Addendum #5

Bid Opportunity: CPS-RFT-25-03 - North Paris Fire Station

PROJECT: North Paris Fire Station

ADDENDUM 01

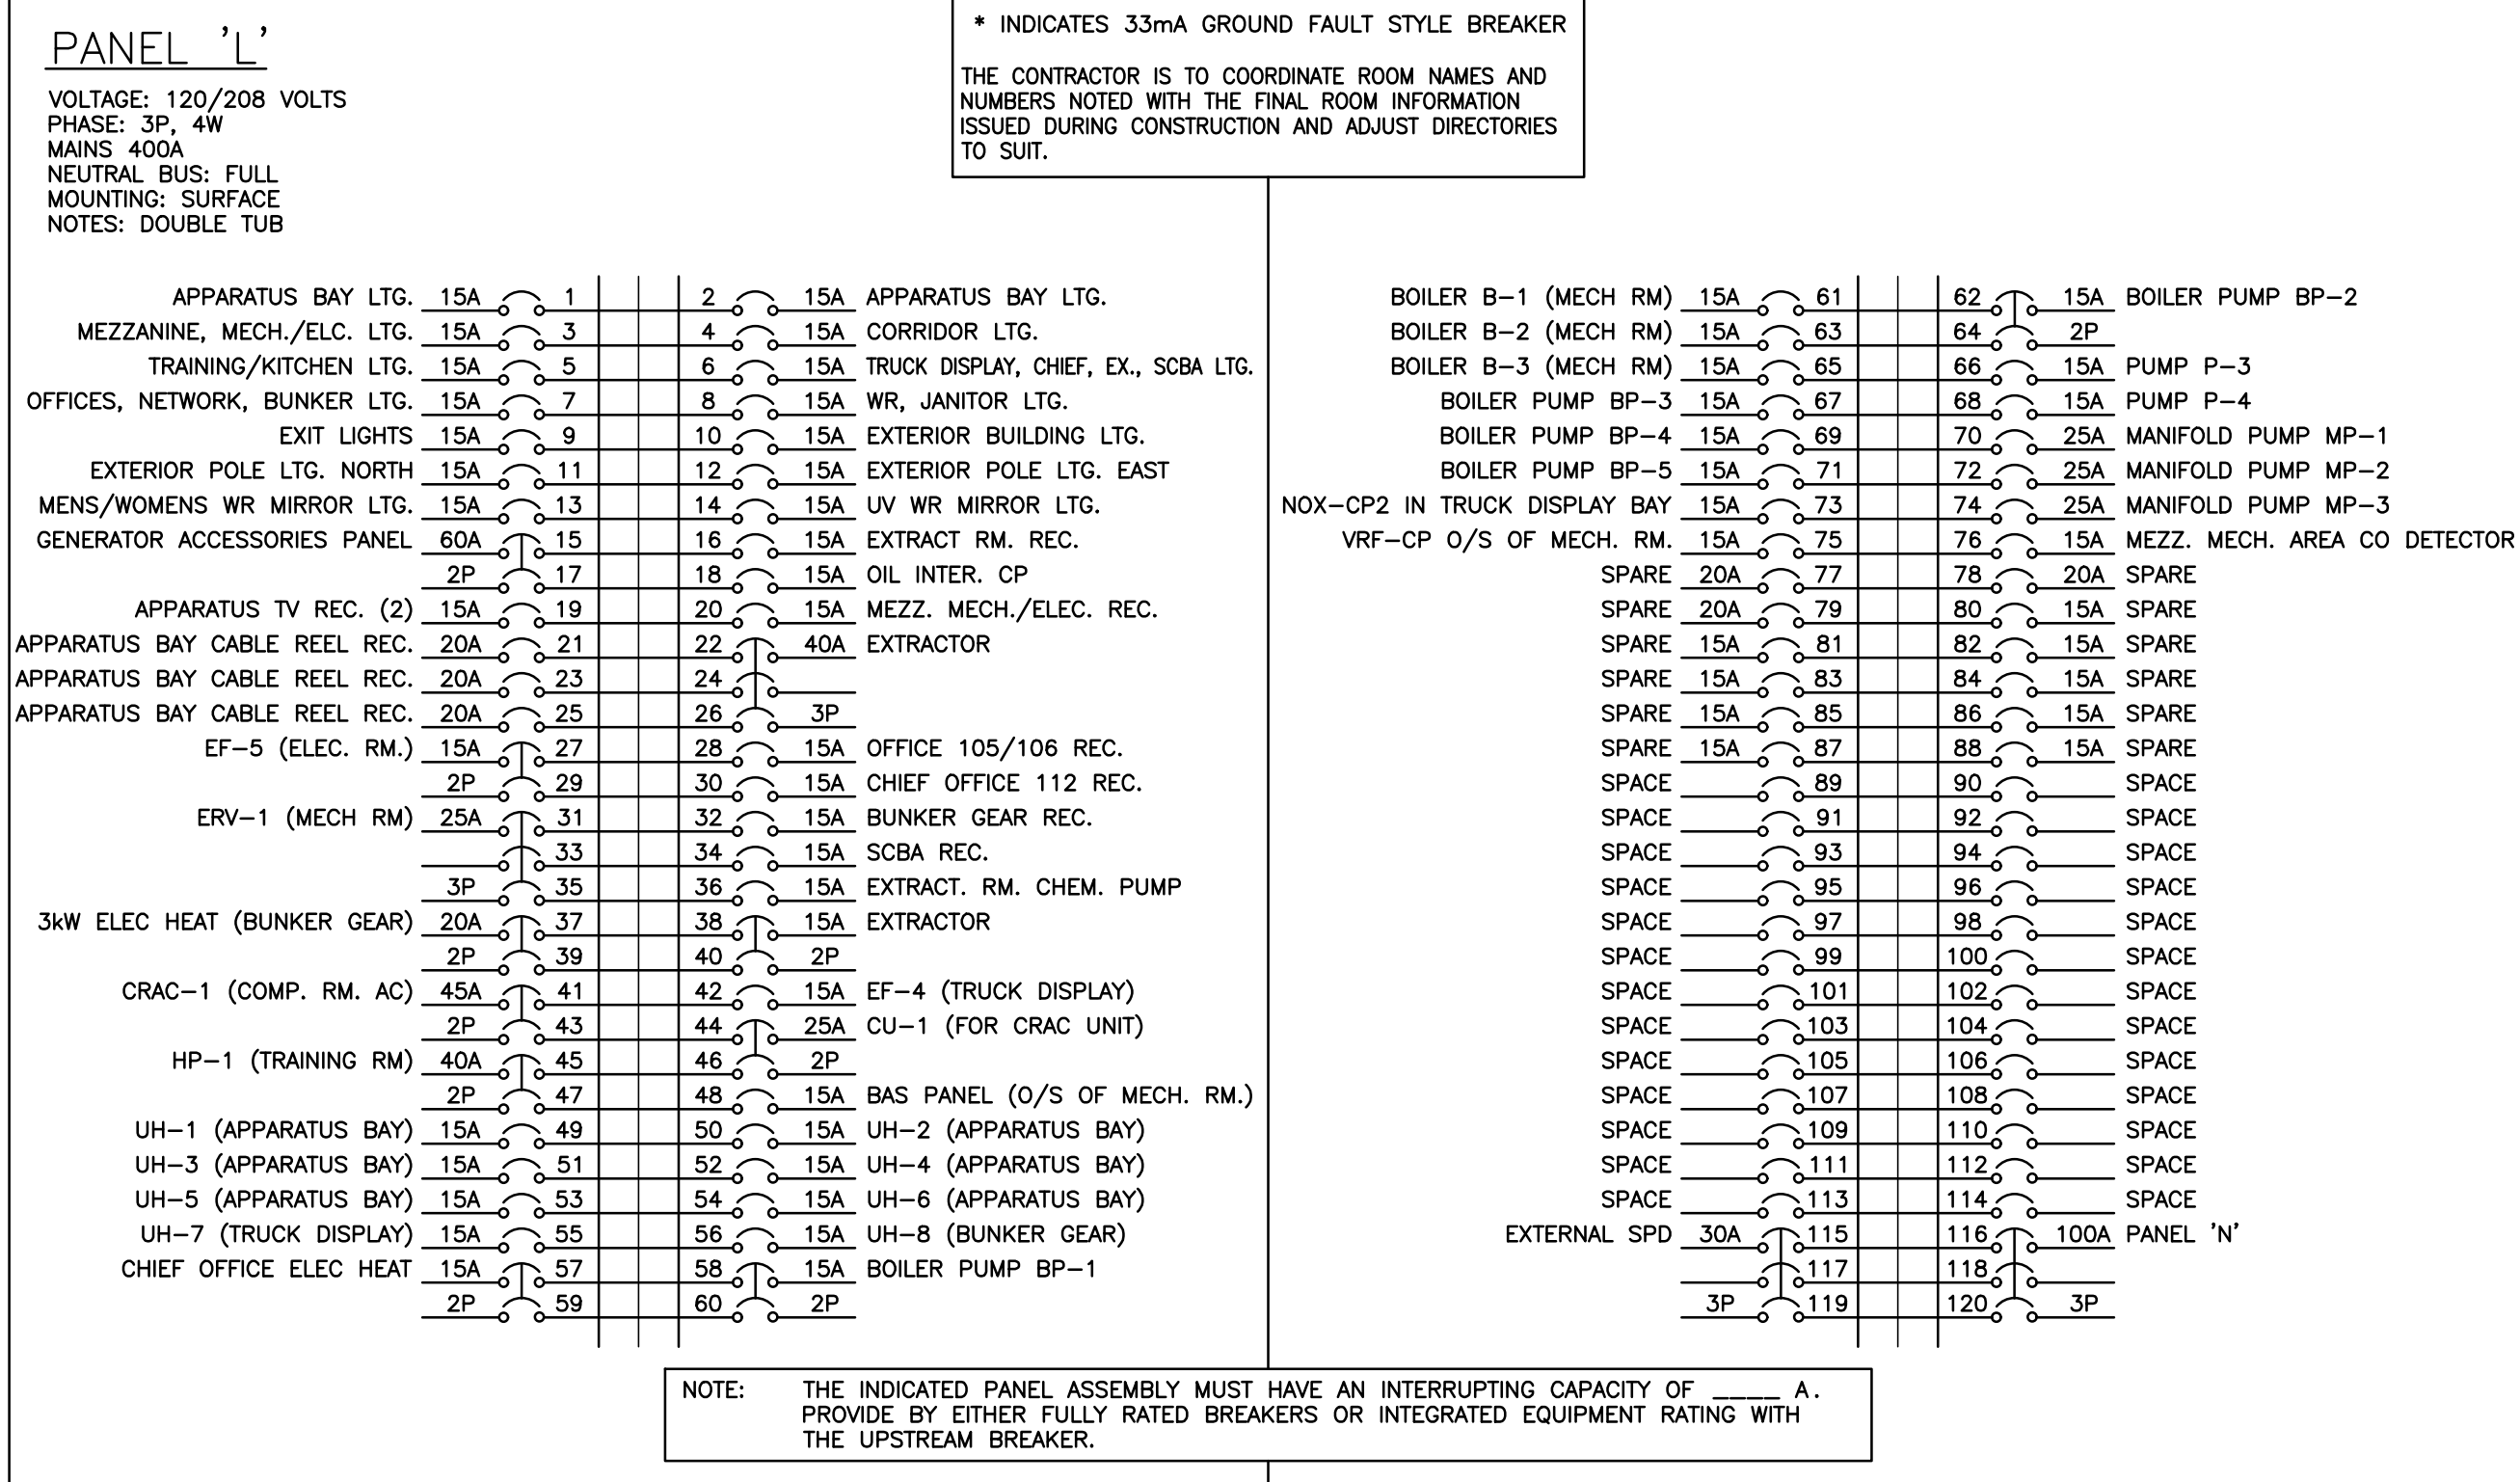
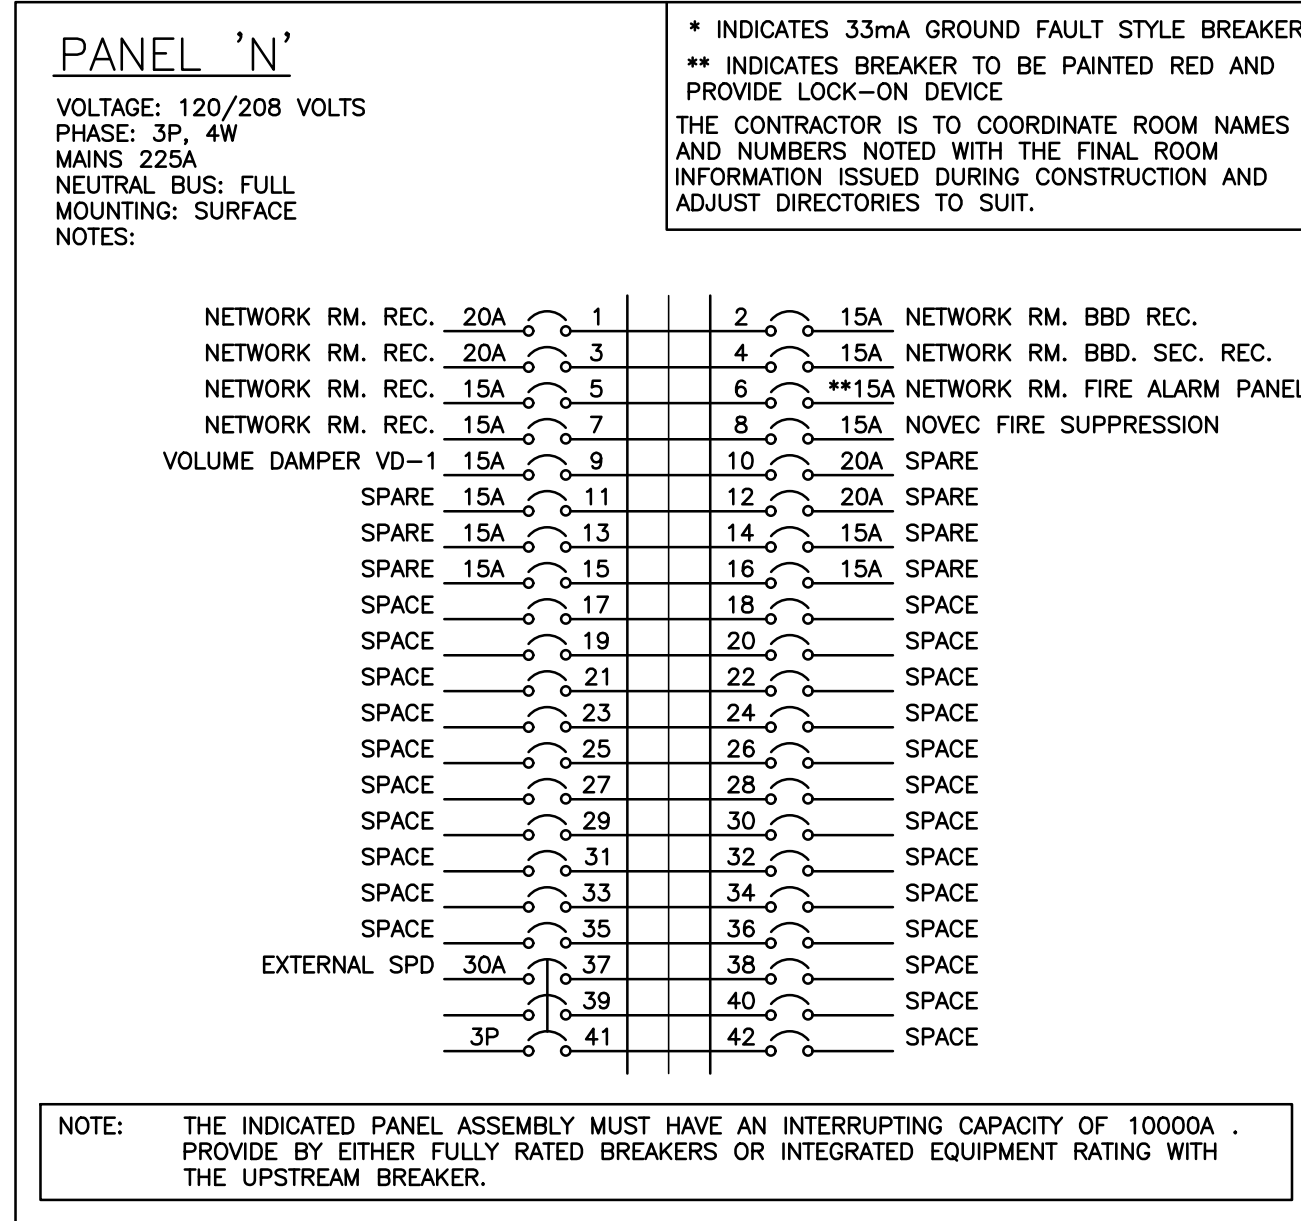
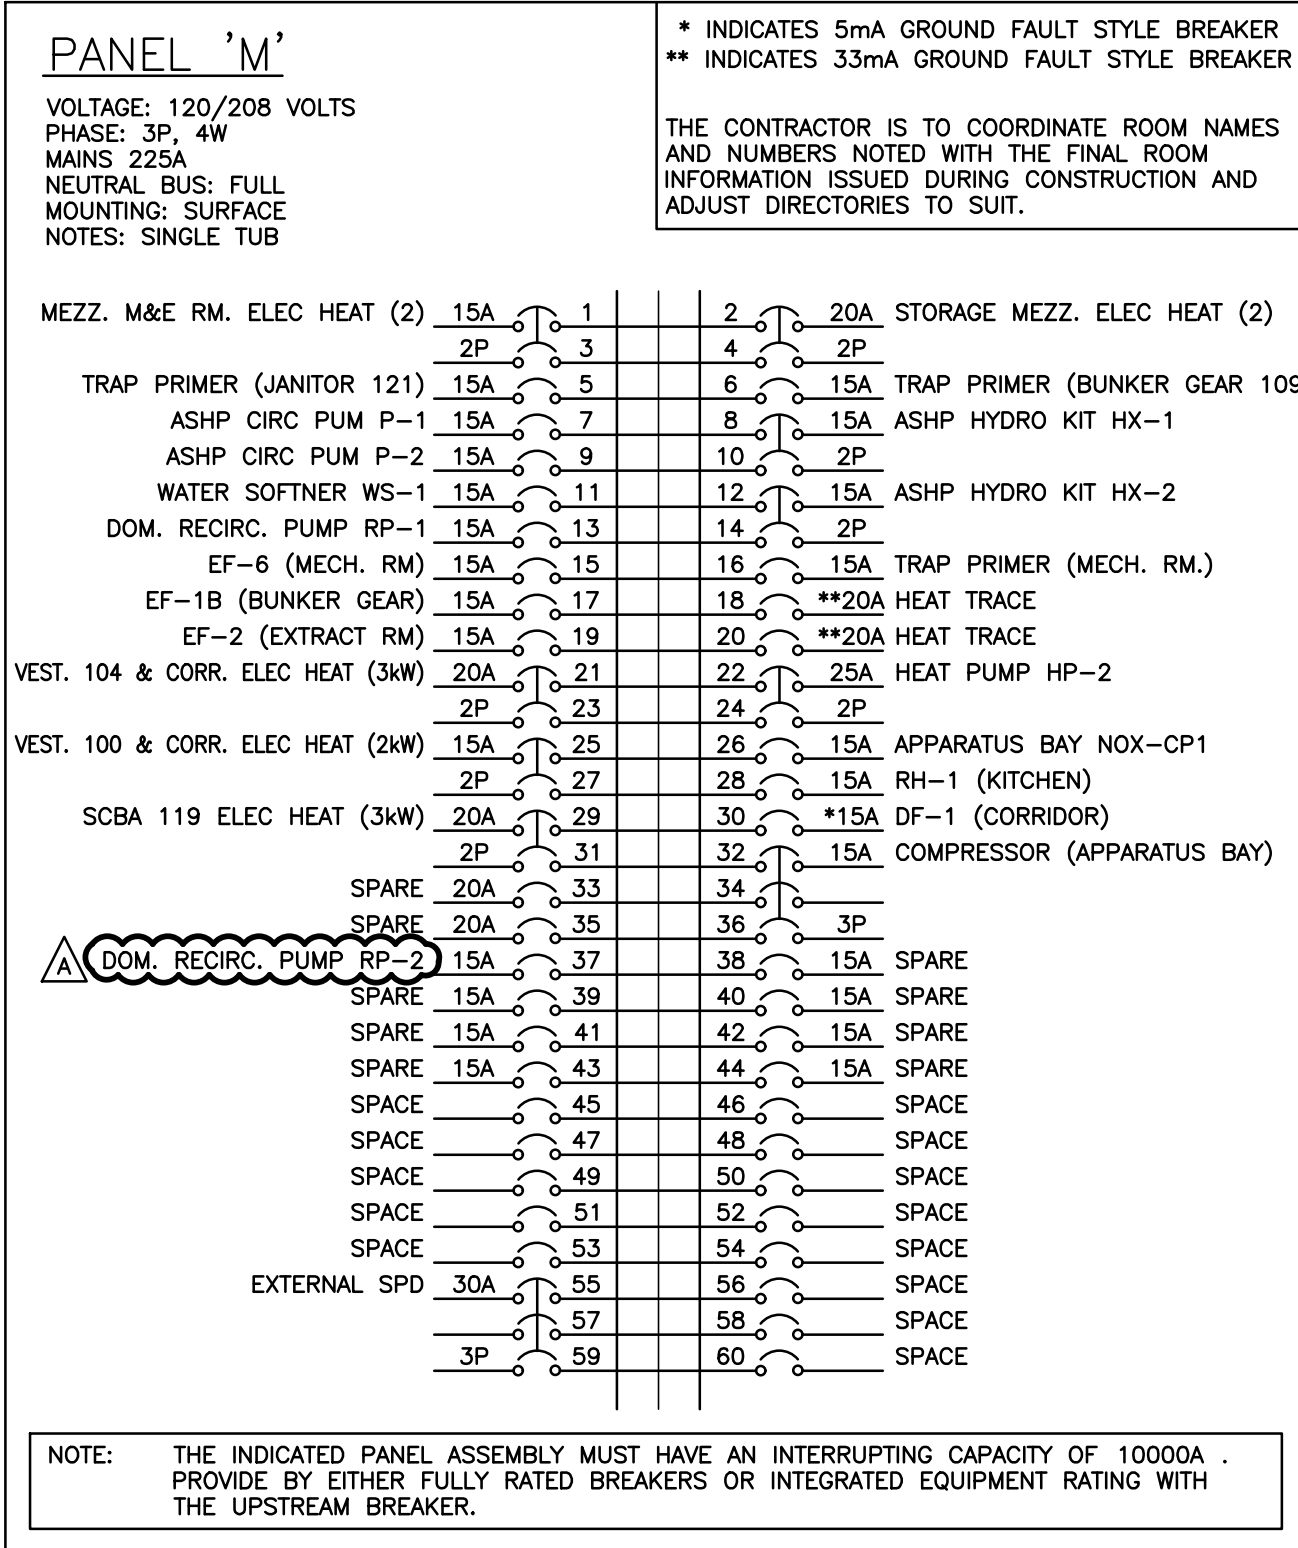
Question 2: 2. There is an incoming main telecom backboard, but there is a note stating there is “conduit for fiber to pole splice enclosure” (detail c, drawing E301). Please provide more information. Where are the two 12-strand lines going, there is one entering the bottom of the data cabinet in the network room shown on drawing E601, and there is also another existing the incoming main telecom backboard. Please provide clarification.

- 4.0 Reference Attached Reissued Drawing E301
 - .1 On Plan 'C' (Network Rm 108 enlarged plan) delete the 1-78mmC for fibre to pole splice enclosure as indicated on attached reissued drawing E301.
